# Access Compliance Report

## Public Rights-of-Way

### (Pedestrian Signals)

Intersection ID: N/A	Main Street:	Cross Street: N/A	Location: N/A
ADA ID: 05FBA05F2E7B	Signal Type: One Push Button-Non APS	Overall Compliance: No	Severity Score: BTN 1: N/A BTN 2: N/A No BTN: N/A
Codes/Mitigation Info/Possible Solution		Field Measurements/Component Compliance

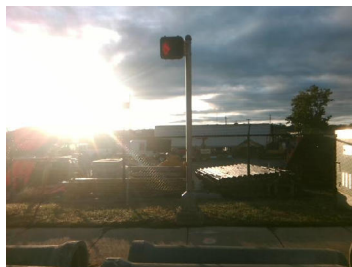
PROW/ADA: TMUTCD 4e.08, R404.3, R404.2, R406.2, R404.7.3

Yes	B 1 Clear Xing Direction?	ClearlyMarked	N/A	B 2 Clear Xing Direction?	N/A
	B 1 Crossing Direction	To N		B 2 Crossing Direction	N/A
Yes	B 1 DistanceTo XWalk (in)	1.0	N/A	B 2 DistanceTo XWalk (in)	N/A
No	B 1 DistanceTo Curb (in)	78.0	N/A	B 2 DistanceTo Curb (in)	N/A
Yes	B 1 Diameter (in)	2.0	N/A	B 2 Diameter (in)	N/A

Possible Solutions: Replace Signal Push Button With APS Button on New Post. Remove & Relocate Sign.
